**NOTICE OF DECISION**  
**Fairfield by Marriott Inn & Suites – 900 Block N Brutscher Street**  
**Design Review/Variance – DR222-0001/VAR22-0002**

Fairfield by Marriott Inn & Suites - Design Review/Variance – DR222-0001/VAR22-0002

REQUEST: Development of a 79-room hotel

Fairfield Inn and Suites Marriott	
901 N. Brutscher Street	
Newberg, OR	
DATE	4/1/2020
PRODUCT	1907
DRAWN BY	MV-NA
LAST NAME	EXTERIOR ELEVATIONS
<b>A211</b>

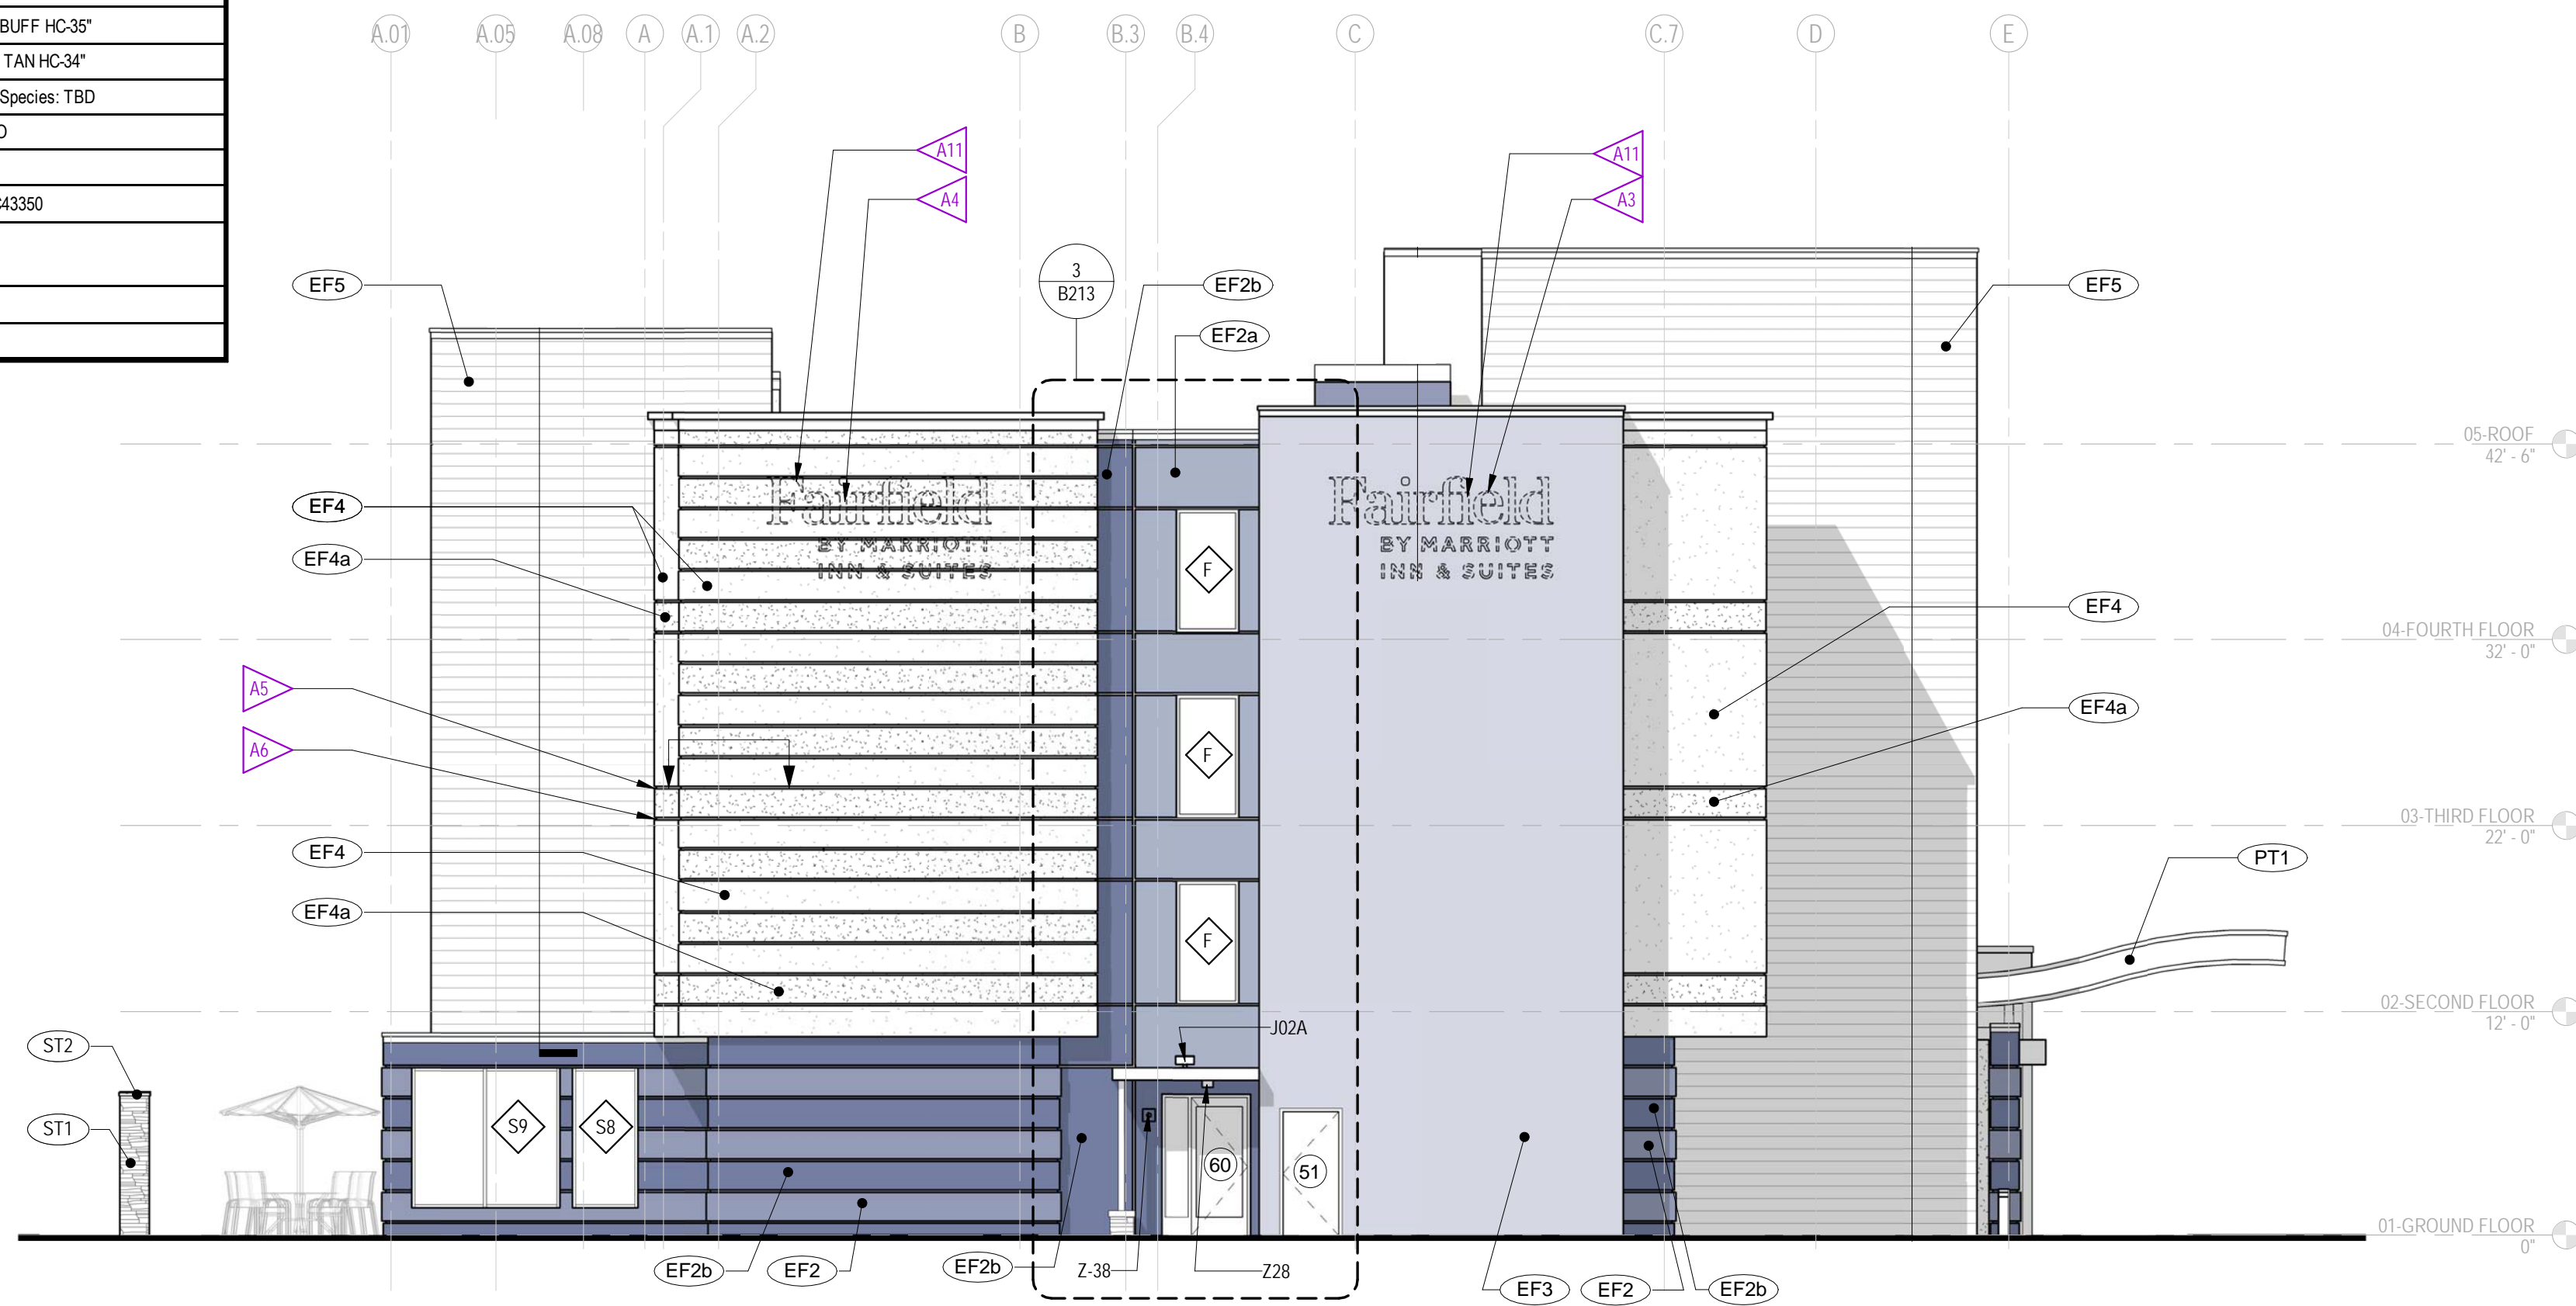
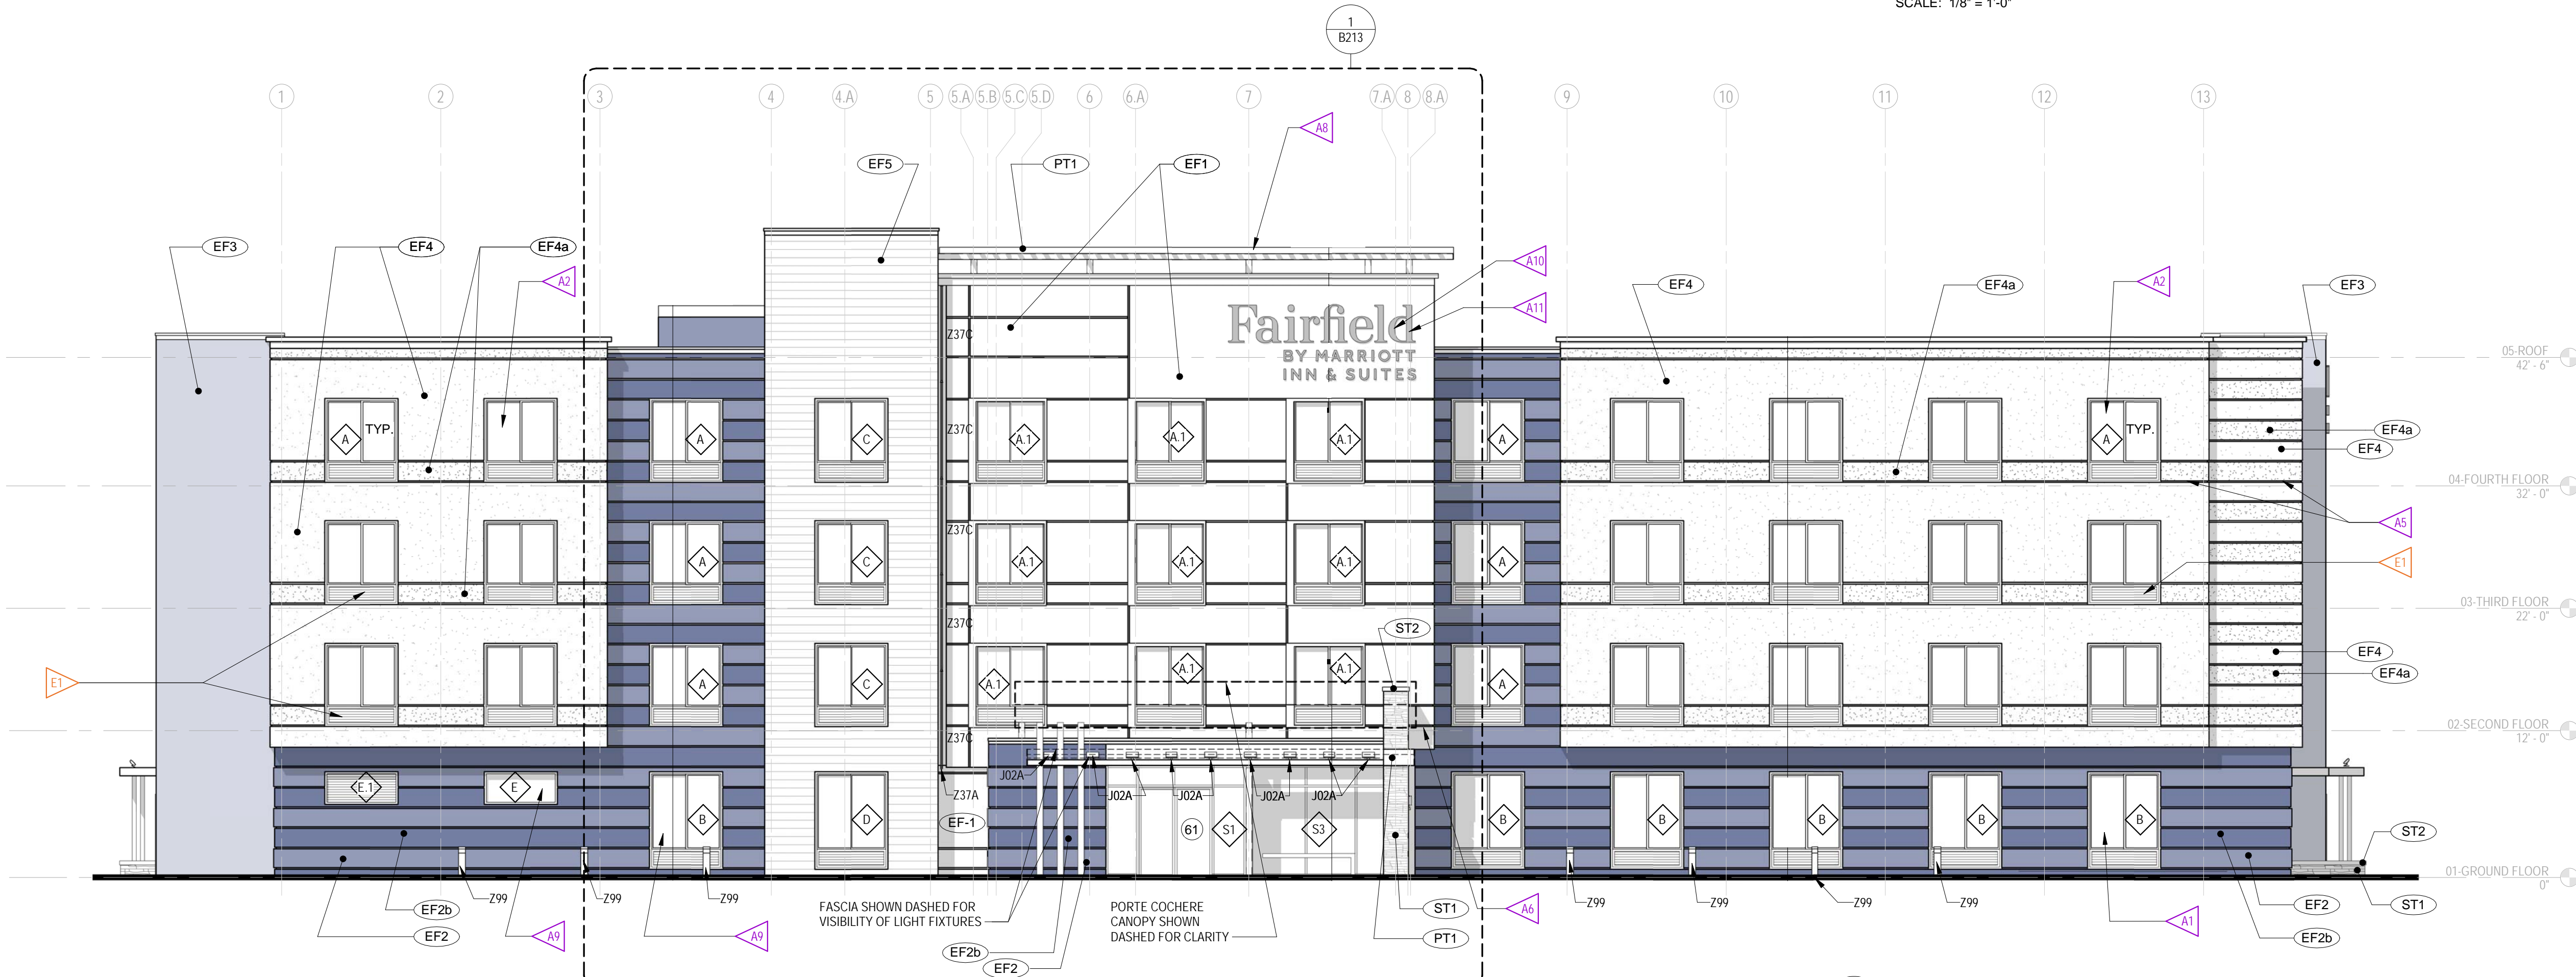
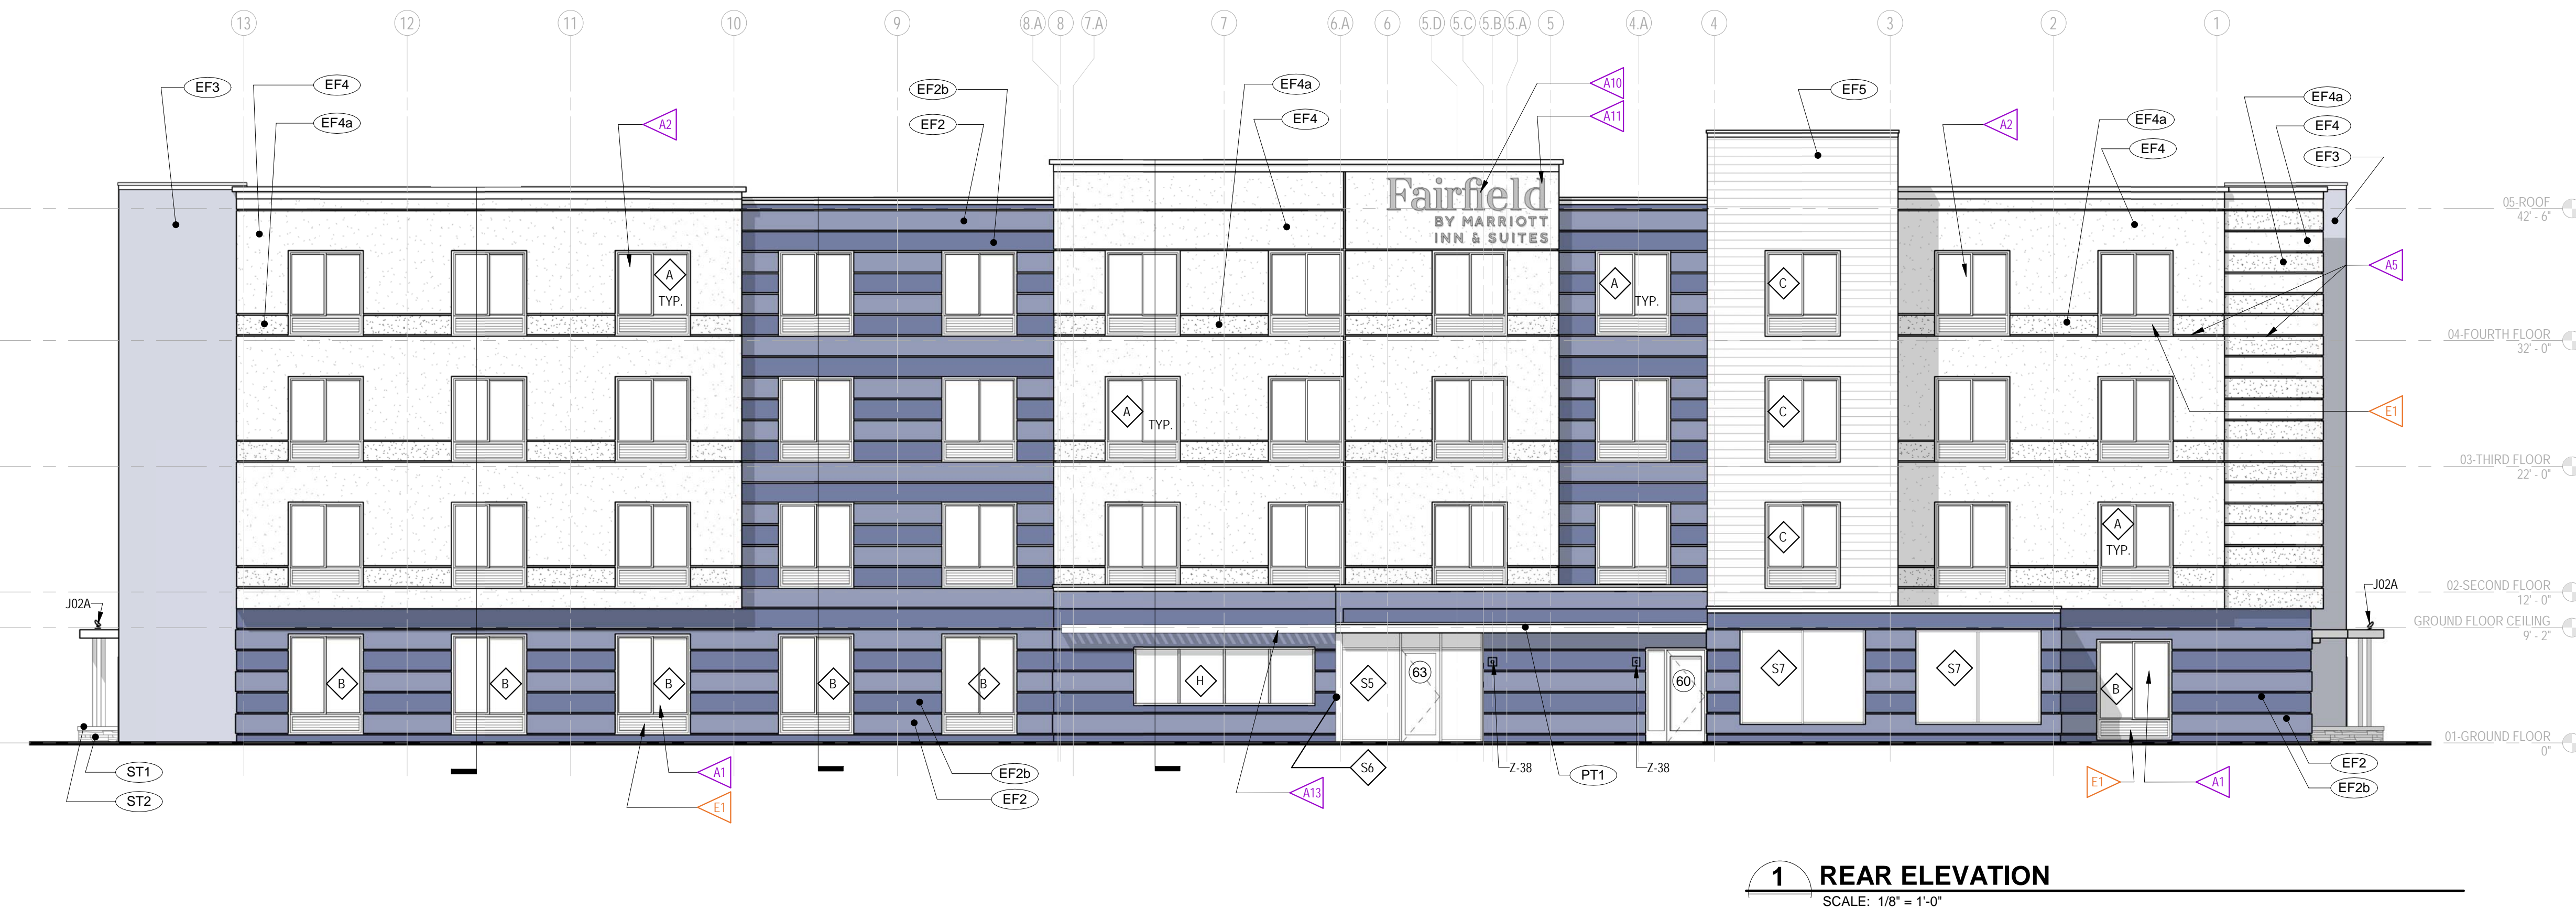
**Finding:** The proposed hotel is a 4-story structure with 79-rooms. The architecture of the building incorporates a variety of building materials including fiber cement siding, wood plank siding, stone veneer, stone coping, and metal. The roof line has varying elevation heights to break up the building mass. In addition, the horizontal planes of the building include recess and relief to break up the building mass along with windows on the four elevations. A porte cochere (canopy) is provided at the main building entrance. The building will be painted a series of colors as detailed on the Exterior Finish Schedule on Sheet A211.
